ADA Compliance Program

Clark County Facilities Transition Plan Public Works Operations Center

Date of Survey: November 5, 2007 and December 6, 2007

Fig. 604.5.1
 Side Wall Grab Bar for Water Closet

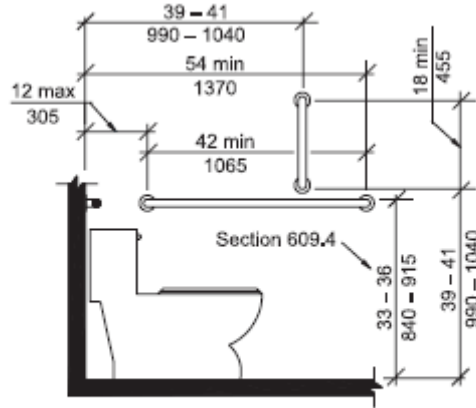
Item # 9
 Issue: Vertical Grab Bars
 Issue: Forward Reach
 Issue: Flush Controls
 Issue: Clear Floor Space
 Location: Conference Center
 Code: ANSI 604.5.1 – Vertical Grab Bar
